Appendix 1B

Stakeholder Consultation and Responses

Re: Proposed Ballycar Wind Farm
Subject: EIA Consultation

Figure 1: Wind Farm Position from Threshold 24

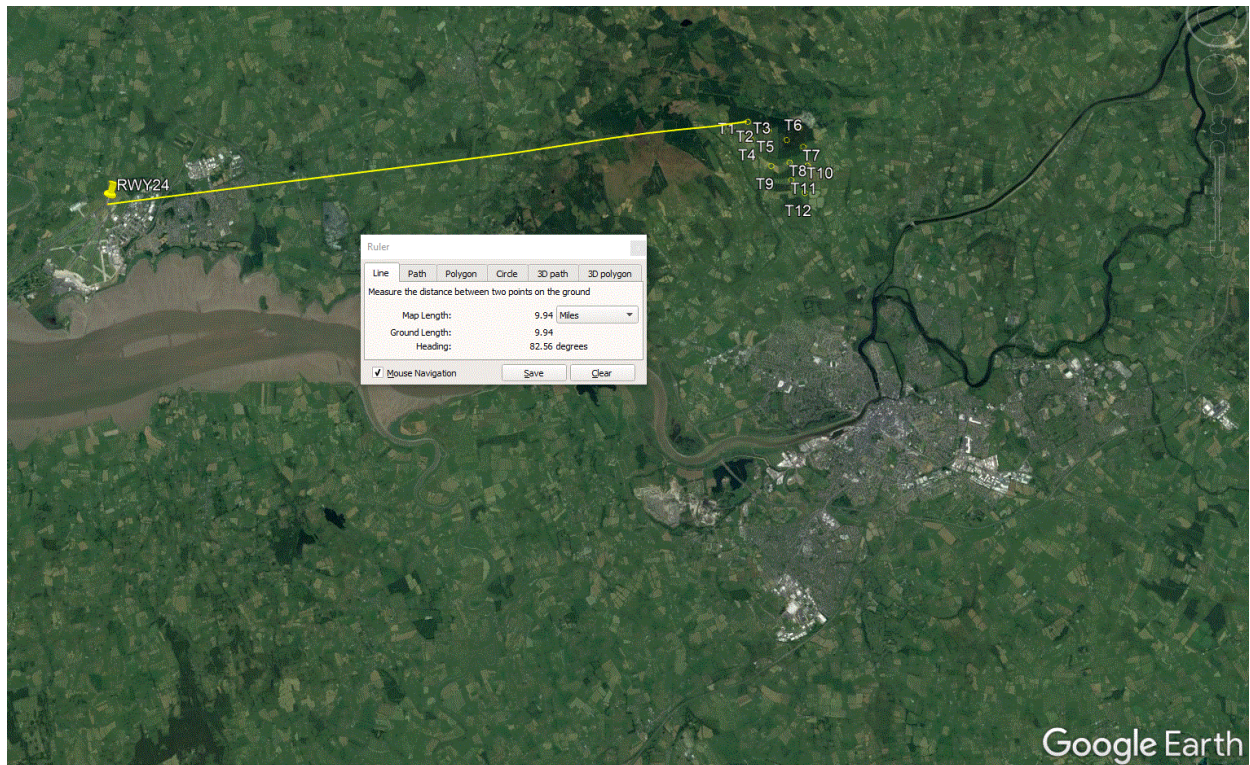
The windfarm does impact to the current published IFPs for Shannon Airport but is only limited to the ATC Surveillance Minimum Altitude Chart. Although a full IFP assessment is normally required for any identified impact, it is recommended to submit this report to the IAA for consideration whether a full assessment is required.
